**Proposed Residential Development on
Land between Houghton Grange and The How**

Houghton Road, Houghton
Application Ref: 23/00627/OUT

**REVIEW OF APPLICANT'S
REVISED LVA**

Houghton and Wyton Parish Council

Figure 4.1: Relationship to Western Periphery Character Area

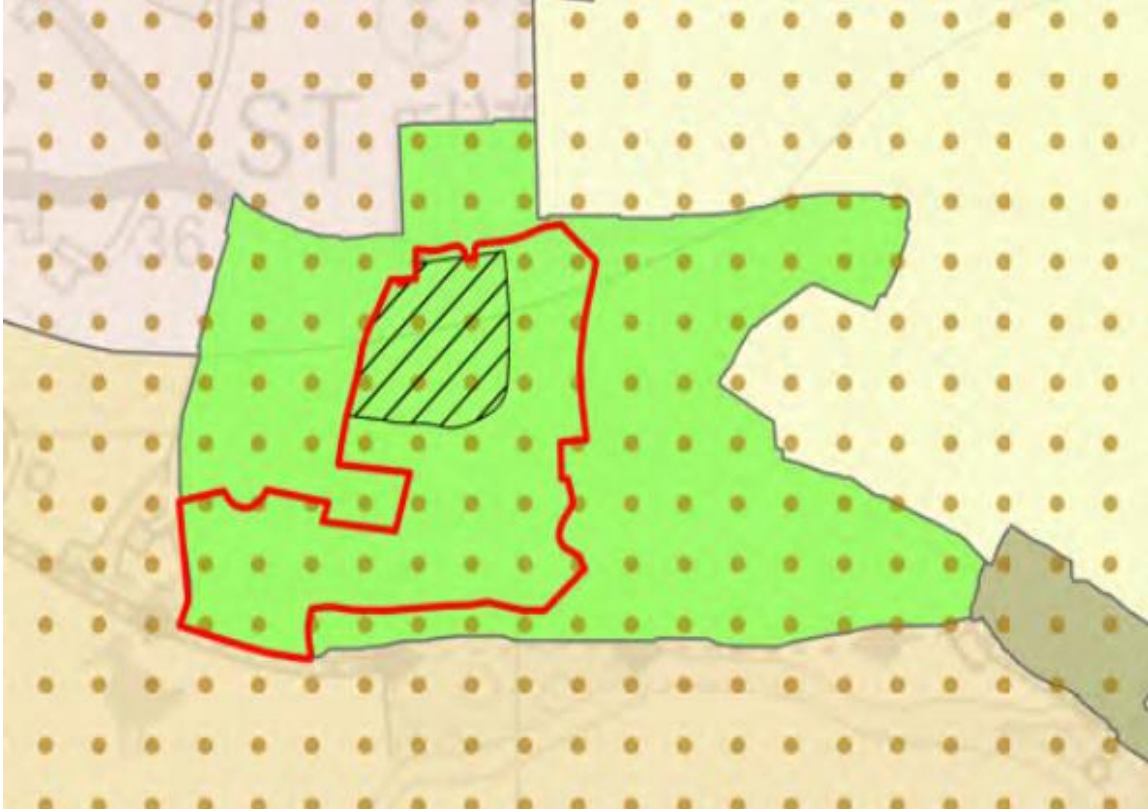
4.3 However, the 2024 LVA does assess the development's impact on the St. Ives urban character areas (CAs), of which the Western Periphery CA - in which the site is located – is most relevant. This is shown as the green-shaded area on **Figure 4.1**.

4.5 Overall, the Western Periphery CA is considered in the revised LVA to be of Medium value and Low susceptibility, giving rise to Medium sensitivity [Ref 2024 LVA, Table 5.2.1-1]. As can be seen from Figure 4.1, the proposed scheme would introduce a cluster of built development up to 10m high onto the central/northern part of the site, which is currently open land. This is

considered in the 2024 LVA to amount to a Low magnitude of change, which in combination with Medium sensitivity gives rise to a Minor Adverse effect at Year 1 [Ref 2024 LVA 9.1.2.3].

- 4.6 In my opinion, the predicted Minor Adverse effect under-states both the susceptibility to change of the green space within this CA, and the magnitude of impact represented by the further encroachment of built development into it. Comparison of Figures 3.1 and 3.2 indicates that there has been no material reduction in this degree of encroachment as the masterplan has evolved, which cannot reasonably be described as a “slight alteration” to the CA [Ref 2024 LVA 9.1.2.1].

- 4.7 The 2024 LVA refers to the retention of a “green wedge of open space” between the development and The Spires. As pointed out in the conclusion to the original LVA review, however, the width of the east/west green gap between Houghton & Wyton and St. Ives (which falls within this CA) would be reduced by about two-thirds. The peripheral and transitional character of the CA – and thereby its contribution to separation between the settlements – would be further eroded by the urbanizing effect of the proposal.
